SERVICE BULLETIN

BRIGGS & STRATTON, LLC

TO: NOTIFIED CUSTOMERS	CRITICAL CORRECTION - ACTION AND RESPONSE REQUIRED IMMEDIATELY	<input type="checkbox"/>
BULLETIN NUMBER: 21-0002-NL-GR	ACTION REQUIRED - FIX, NO REPORT	<input type="checkbox"/>
DATE OF NOTICE 10/16/20	IF ENCOUNTERED - CORRECT IF ISSUE IS FOUND	<input checked="" type="checkbox"/>
SUBJECT: NL-GR SERIES DIESEL UPDATES	INFORMATION ONLY	<input type="checkbox"/>
PRODUCT LINE: NL-GR SERIES	AUTHORIZED LABOR CHARGES FOR THIS BULLETIN: .5 HR / \$50 PER UNIT	
MODEL: DIESEL	PART NUMBERS REQUIRED TO CORRECT THIS BULLETIN: 1 ea 119000 1 ea 056029 (alternate kit: 1 ea 047009 and 1 ea 046039) 1 ea 057001	
SERIAL NUMBERS: 25-000001 THROUGH 25-000090		
EXPIRATION DATE: 12/16/2020

Item 1: Door does not latch with existing "L" latch bracket. If encountered, install "U" latch bracket.

SECTION A-A

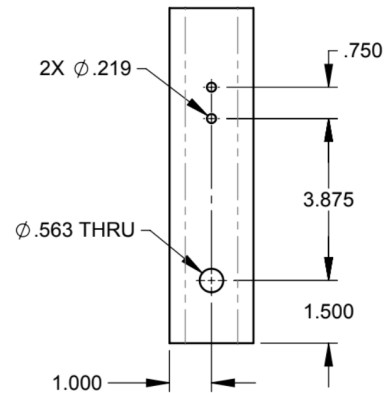
USING THE APPROPRIATE DRILL BIT, LOCATE EXISTING .218" HOLES (2ea), OPEN HOLES TO .281" AND DRILL ALL THE WAY THROUGH THE LIFT BOW. REMOVE EXISTING LATCH BRACKET.

USING HARDWARE, INSTALL THE U SHAPED LATCH BRACKET (119000) USING BOLT (056029) AND TIGHTEN WITH NUT (057001).
